**Product:** Viper

**Subject:** Check Valve Addition on CO2 line.

**Date:** 11/07/24

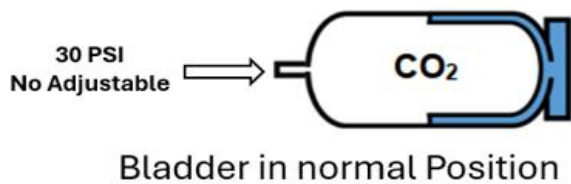
Starting with the Viper unit serial number 74E2344VP002, we have implemented a check valve at the factory to prevent overpressure from being generated inside the expansion tank due to high temperature during transportation and storage of units. This check valve also helps to avoid depressurization of the expansion tank during the CO2 tank change in the unit already in service.

1. Syrup contamination all CO2 lines including all CO2 regulators and water pump and solenoid valves.
2. Prematurely ruptured internal bladder of expansion tank.
3. Leaks of Syrup or product CO2+Water.

Factory recommendation if you are replacing the expansion tanks due to a broken bladder in a unit prior to serial number 74E2344VP002 is to additionally install the check valve PN.-620609162 at the inlet of the CO2 regulator that is set to 30 PSI to avoid depressurization of the expansion tank. See diagram for installation and location marked in yellow.
